C2062 KOREAN FIRMWARE RELEASE NOTES

Ishida Uni-7 Series with PK-260B CPU Board

Version C2062 features & changes [13 January 2016]

PK-260B with SD Memory Card Slot

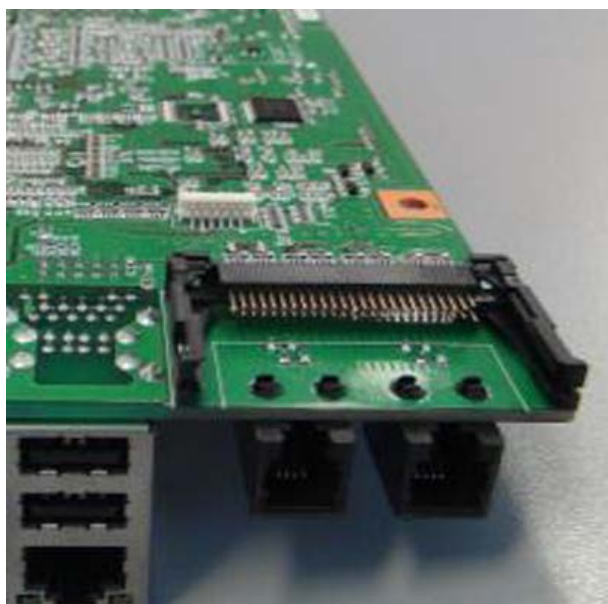
Firmware C2062x is designed for the revised CPU board PK-260B. **This firmware is not compatible with the previous CPU board PK-260A.** And previous firmware (C1828x) is not compatible with the new PK-260B CPU board.

The two CPU board versions can be easily identified by the expansion memory card slot located on the left side of the Uni-7. See the images below.
